1. Legal Ad

2. Agenda

3. 1190 Brighton Avenue

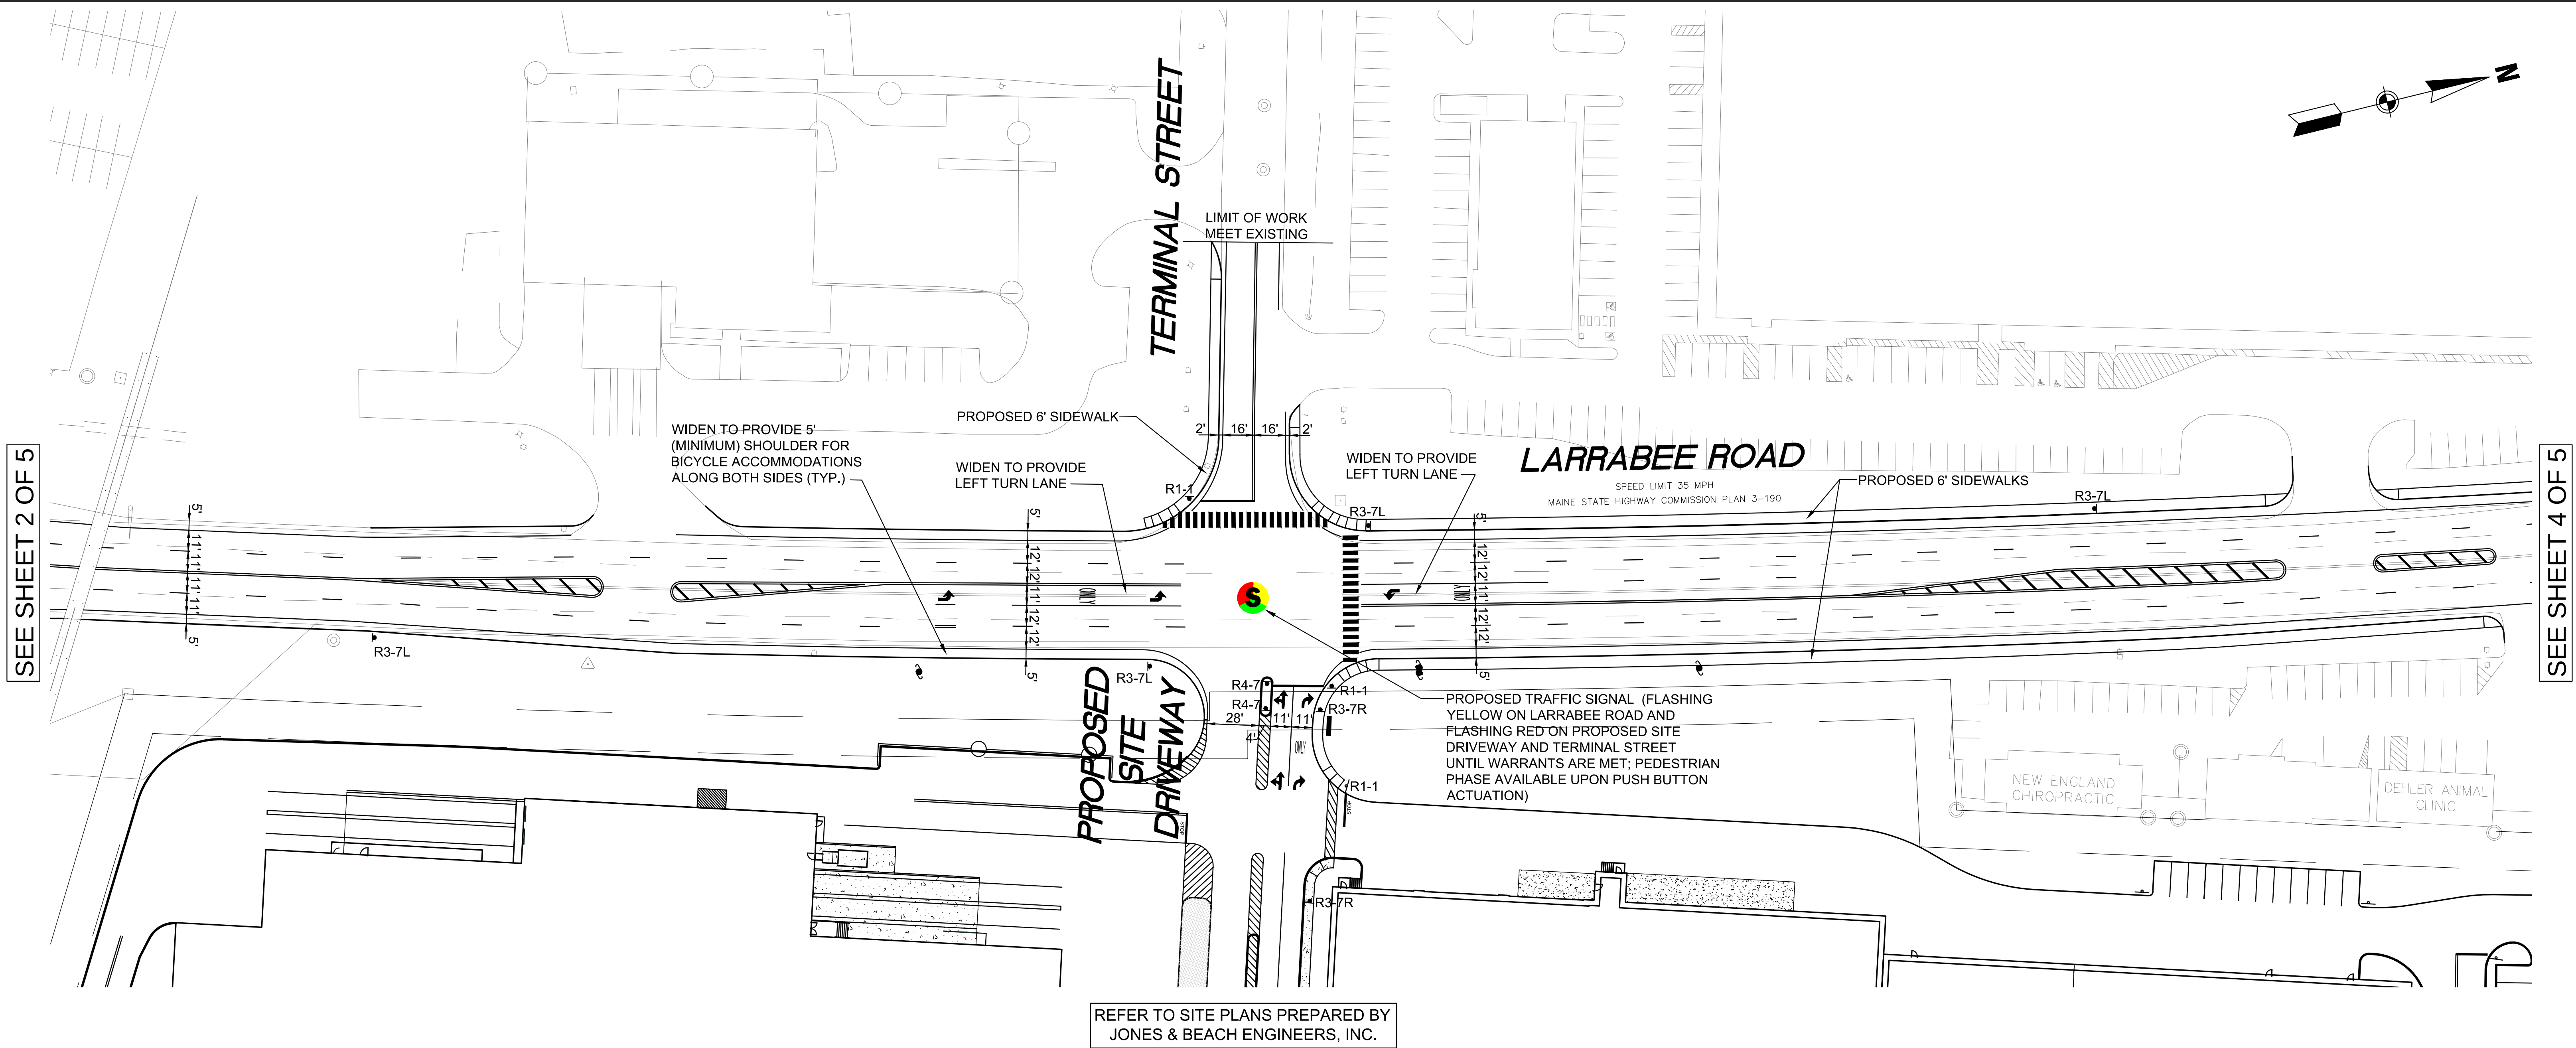
[*Portland Staff Note:* The TMP should require updated signal heads with reflective back plates (as proposed on the applicant's Conceptual Improvement Plan, Sheet 4 of 5), and updated thermal (not video) detection to the City's standard.]

Response: The Main Street right-turn entrance only driveway to the Project site that was to be located east of Larrabee Road has been eliminated and is reflected on the revised improvement plans that are included herein (Figure 14, Sheet 4 of 5).

Response: Pedestrian traffic signal equipment and phasing will be provided at the Main Street/Westbrook Crossing (Kohl's)/Dirigo Plaza intersection. In addition, as discussed with the Westbrook Planning Board, the crosswalk across Main Street has been relocated to the east side of the intersection so as to align with the sidewalk within the Project site (see Figure 14, Sheet 4 of 5)

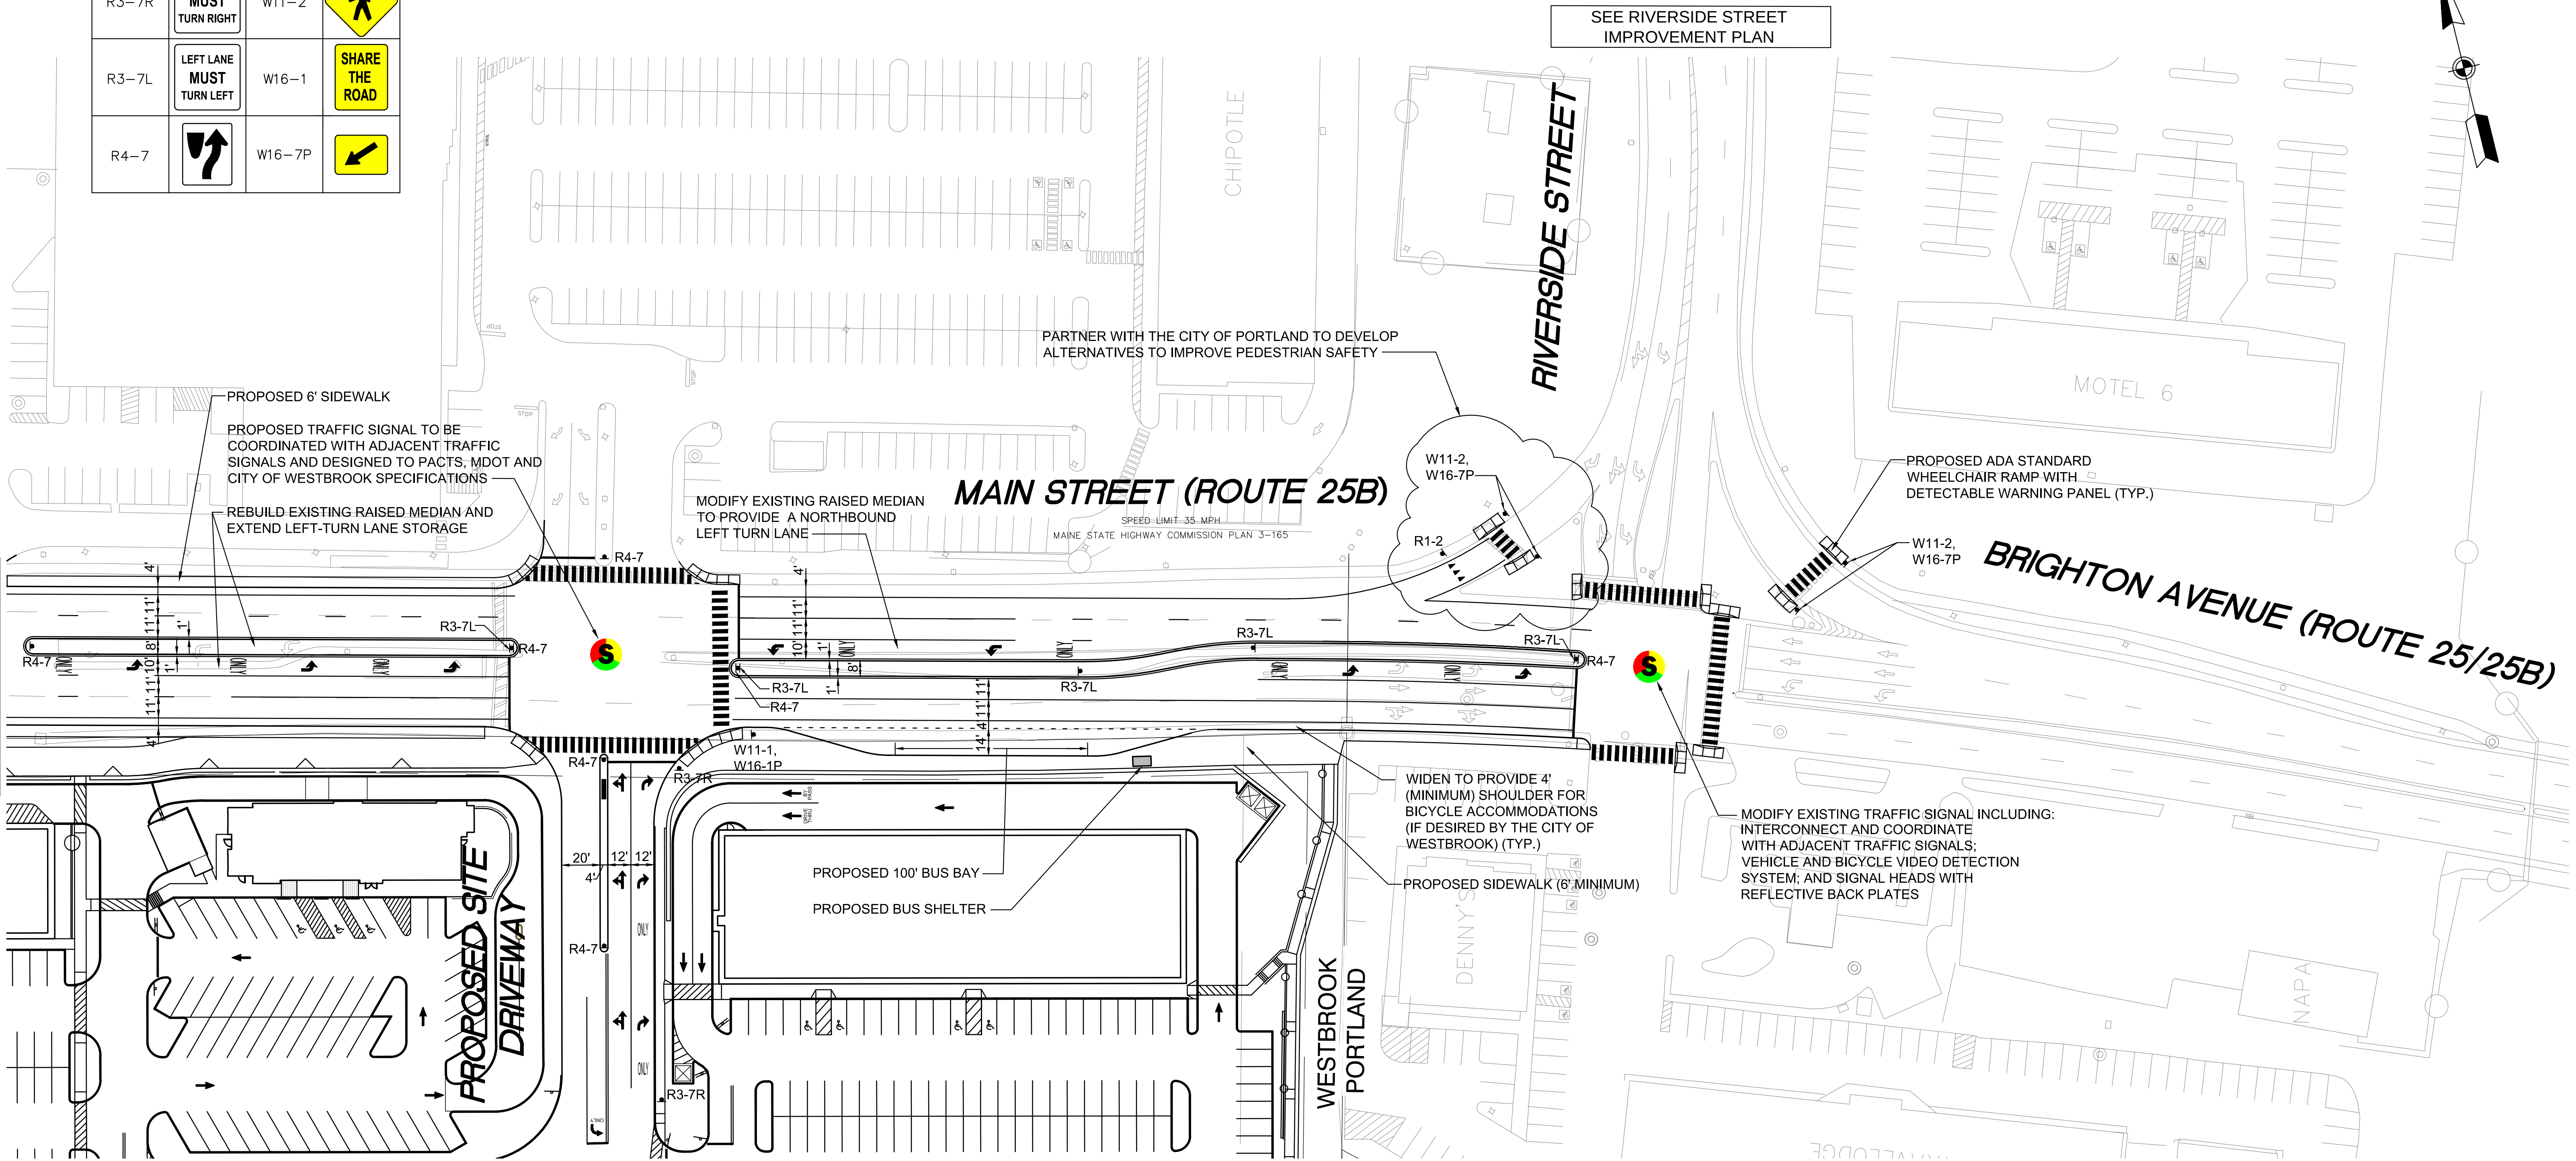
The **Applicant agrees** to these improvements as part of its mitigation plan, some elements of which are included in the Ransom Brighton Avenue improvements plan; the sidewalk location can be adjusted within the limits of the right of way. (See VAI Figure 14, Conceptual Improvement Plan, Sheet 5 of 5).
